14448 22 October 2015

#### WENONA SCHOOL PROJECT ARCHIMEDES (SSD 6925) RESPONSE TO ADDITIONAL SUBMISSIONS

## Tree Replacement Statement and Plan

Re: Wenona School – Project Archimedes (SSD 6925)

A supporting tree location plan has been prepared identifying the proposed tree species positions within the campus.

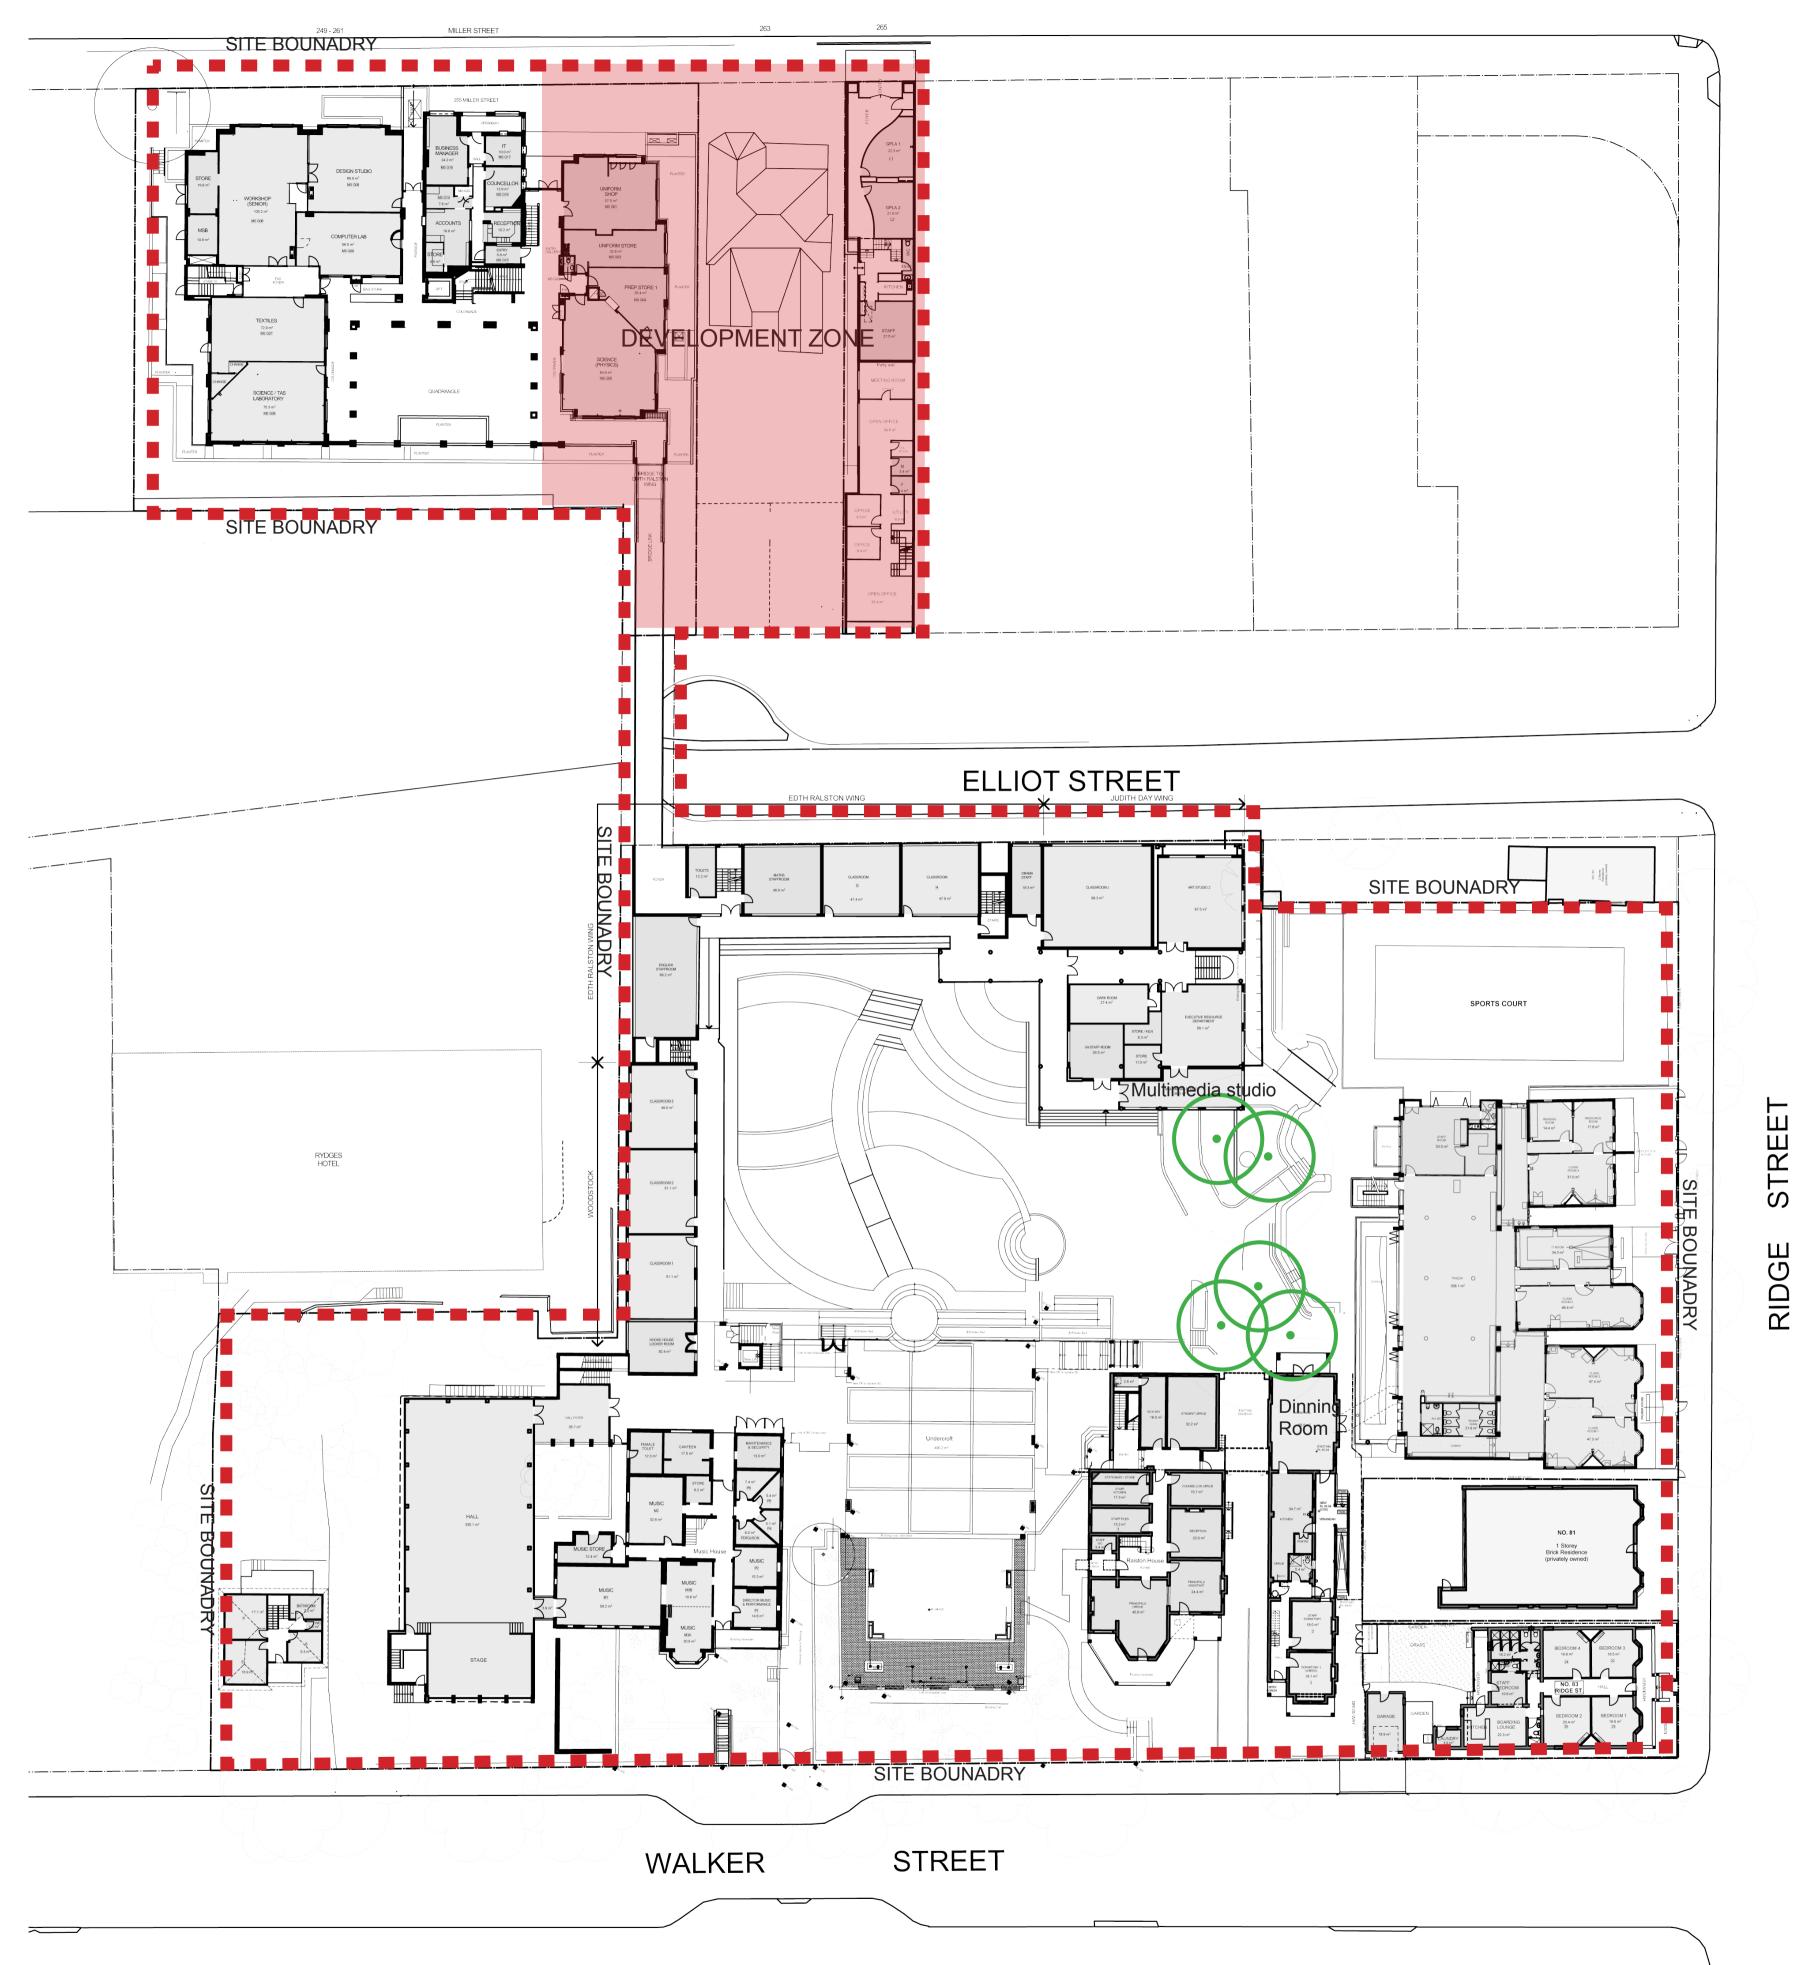
- 3. With respect to tree replacement, please refer to the statement and tree replacement plan prepared by the Landscape Architect, 360 at **Attachment B**. Due to the constraints of the site and the campus more generally, it is not feasible to replace all 10 trees that are proposed to be removed. To limit competition and potential tree death, it is proposed to plant 5 replacement trees in the central courtyard, as shown on the plan.

Further to the Departments concern raised regarding the replacement of existing trees identified for removal, we provide the following response. Please note that this letter is supplementary to JBA Urban Planning Consultants previous response dated 23<sup>rd</sup> September 2015, and intends to further clarify the proposed locations of the noted fice (5) additional tree plantings.

There is insufficient space within the immediate subject site to accommodate additional tree planting, however a detailed investigation of the wider campus has identified two (2) suitable locations for additional supplementary tree planting to offset those identified for removal on site.

The campus is currently populated with a varied mix of tree species, with *Shinus*, *Jacaranda*, *Pyrus*, *Largestromia*, *Acer* and a mix of palm species accounting for the majority. The gardens are in good repair, well maintained and provide limited opportunity for additional planting as they are already heavily treed. For this reason, it is our determination that it is most appropriate to provisionally replace the ten (10) trees identified for removal on the subject site with five (5) additional tree plantings, this will mitigate the potential for competition and potential tree death. We propose to plant 5 x *Lophostemon confertus* within the central courtyard, as these are a local native, long lived, quick growing, evergreen tree which will provide a counterpoint to the predominance of deciduous species within the campus and balance the necessary removal or a large *Camphor laurel* (noxious weed) due to poor health and safety. Furthermore they have a non-invasive root system, and wont pose a threat to the foundations and infrastructure of the school buildings.
